RE: Project Name: BAAF – BASH Tree Clearing and Soil Stabilization
Project Number: 02A7023052
Project Location(s): Bryant Army Airfield, Joint Base Elmendorf-Richardson, Alaska

Addendum # Three (3)

Woodlots

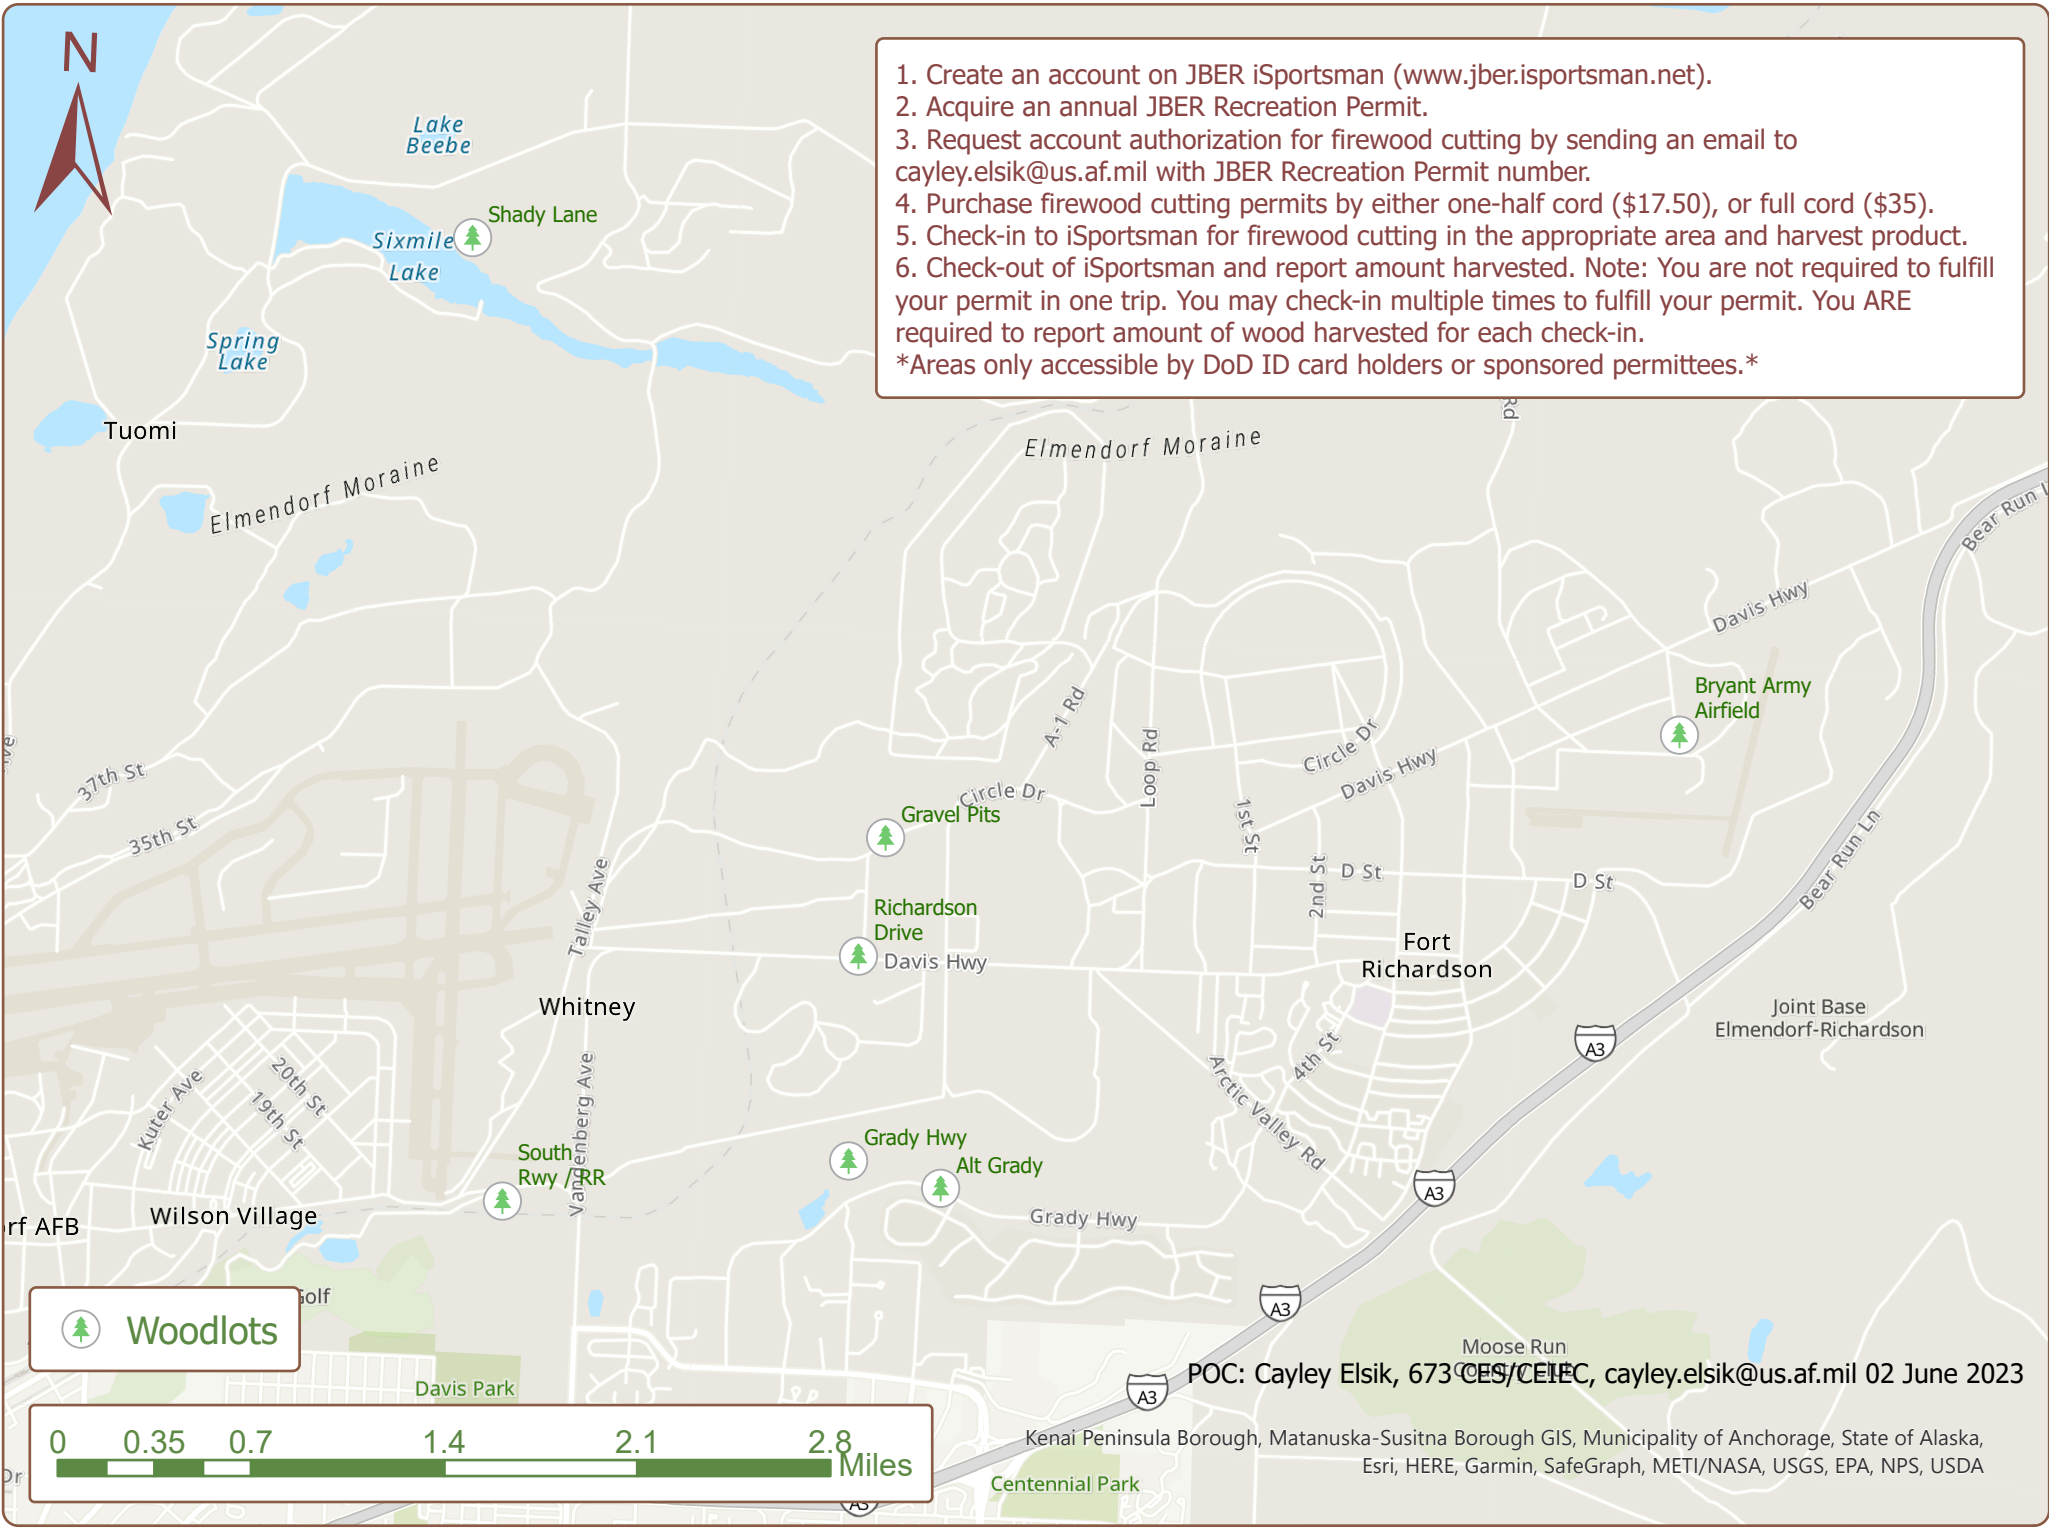
1. It states in the General Requirements that Grading is part of the SOW. Can you expand on the specifics of the Grading? The hole that we looked at yesterday, is that needing to be filled?
 - A. Grading is required to level out any and all mounds to create a relatively flat surface to help with visibility on the airfield. The giant hole as seen on the hill shade map attached to the ITB on the south end of the airfield under phase 1 of work will not be required to be filled at this time.
2. Is density testing required when performing the compaction?
 - A. Density testing will not be required.
3. What is the stump height requirement?
 - A. Stumps will be required to be grinded down to ground level as to reduce issues in the future for grounds maintenance purposes (e.g., mowing, training activities, etc.).
4. Where is the log lay down yard located?

10. Is there a SWPPP requirement?
A. Yes, there is. A dig permit will also be needed.
11. Per Addendum #2, Question #1 states that Stumps are to be removed-hauled off site. It is imperative that we know where they to be hauled off to for pricing purposes.

A. Stumps may be ground down to ground level, any removed stumps will be the contractor's responsibility to dispose of off base.
12. Per Addendum #2, Question #2 it states that the wood lot will be determined before work is performed. It is important that we know now so we know how much its going to cost to haul the limbed wood off site.

- A. Please see attached map. Additionally, for the log lay down yard- these will need to be placed in the Gravel Pit lot just north of the Richardson/Davis Highway lot. The Davis Highway woodlot is being removed as a designated woodlot for other project purposes. Lastly, to reduce activity on the runway and taxiway (vehicle traffic, etc.) coordination between the contracted vendor, project manager and airfield management is essential to ensure the safety of all projects and operations conducted on the airfield.

A. Please see attached map indicating woodlot location. For the log lay down yard- these will need to be placed in the Gravel Pit lot just north of the Richardson/Davis Highway lot. The Davis Highway woodlot is being removed as a designated woodlot for other project purposes.
